RE: Compliance Recall 03V-040

Coachmen has decided that the brake system warning indicator that Ford Motor Company provides in the dash instrument panel of their F53 Class A Motorhome Chassis does not conform to the requirements specified in Federal Motor Vehicle Safety Standard (FMVSS) No. 105 S5.3. Affected units were manufactured by Ford Motor Company from May 13, 1999 through October 22, 2002.

FIGURE 2

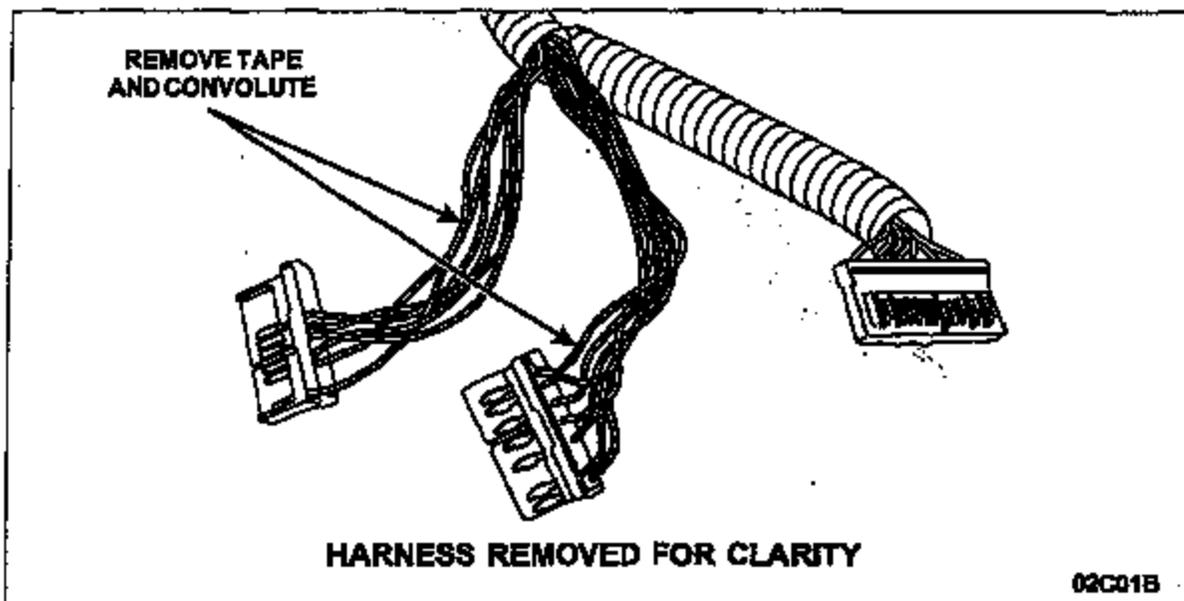
3. Remove the tape and the convolute from the C250A and C250C harnesses up to the point they join the main harness. Retain the convolute. It will be reinstalled. See Figure 2.

FIGURE 3

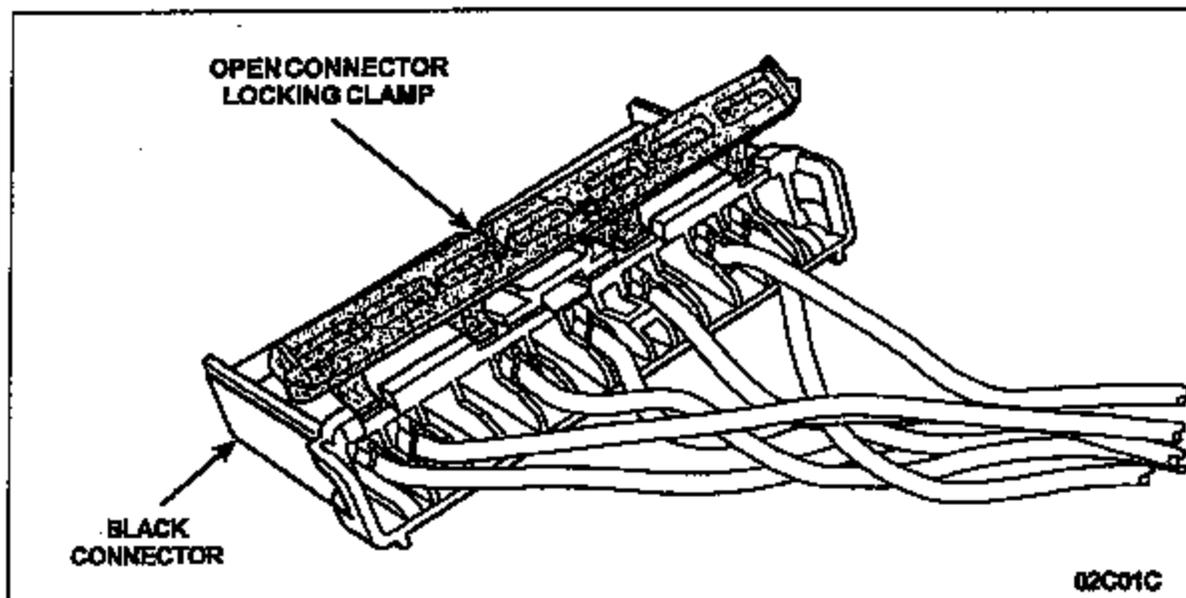
4. Open the black 12-pin connector locking clamp. See Figure 3.

FIGURE 4

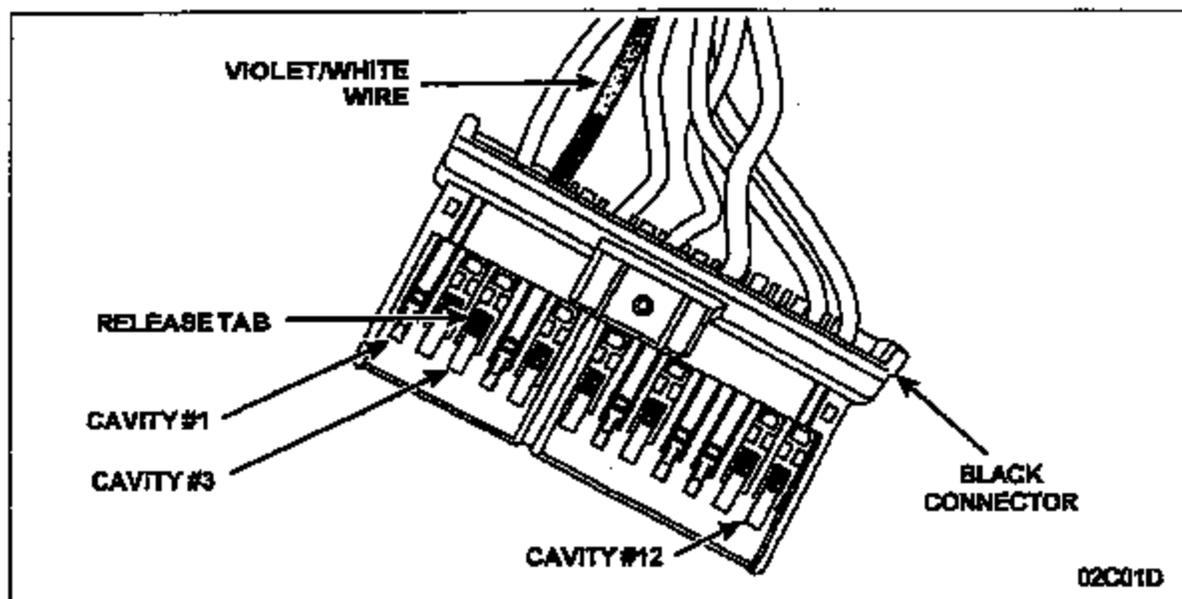
5. Remove the VIOLET/WHITE wire from cavity No. 3 by pushing the small release tab and pulling the wire out of the cavity. Then, close the locking clamp. See Figure 4.

FIGURE 5

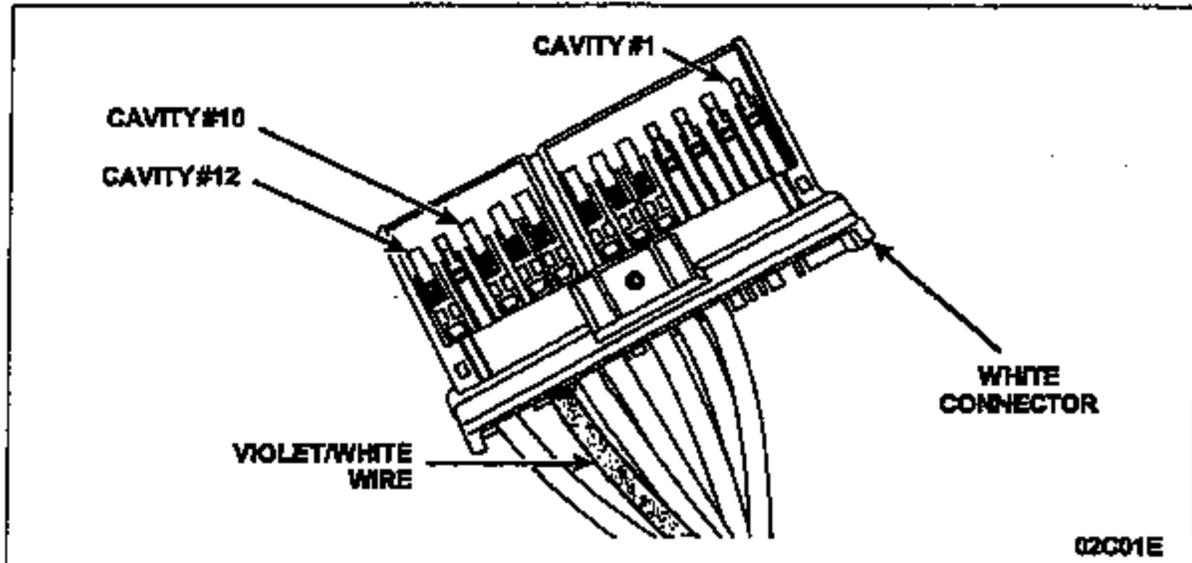
6. Open the white 12-pin connector locking clamp and install the VIOLET/WHITE wire into cavity No. 10. Pull the white wire with light force to make sure it is fully seated. Then, close the locking clamp. See Figure 5.

FIGURE 6

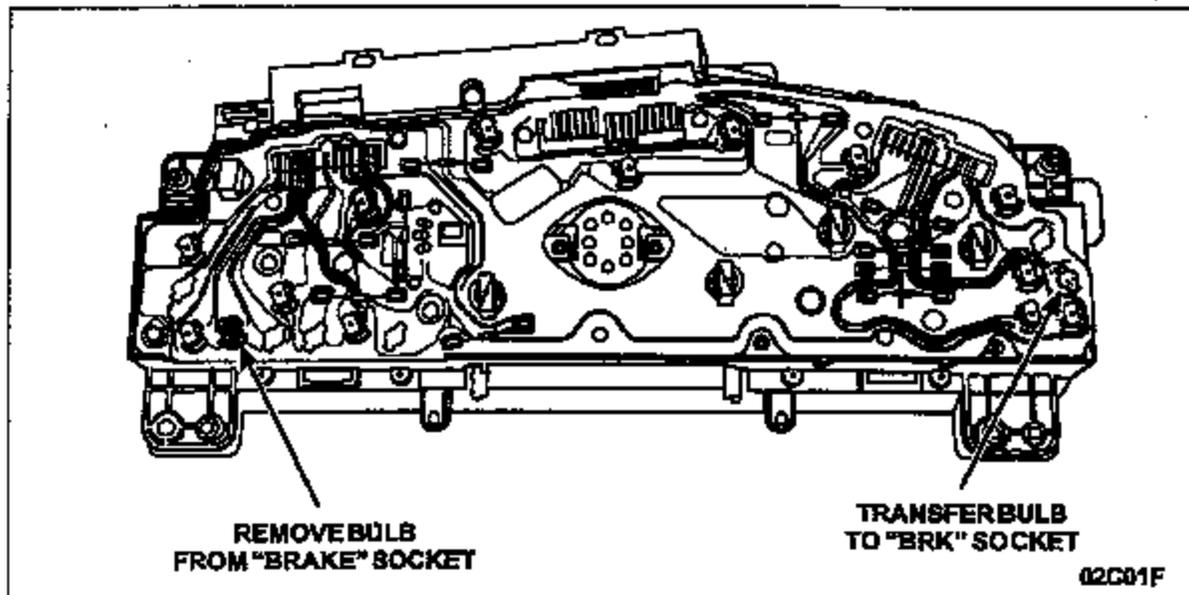
7. Install the convolutes and retape both harnesses.
8. Remove the bulb from the "BRAKE" socket and transfer it to the vacant "BRK" socket located on the opposite side of the cluster. See Figure 6.
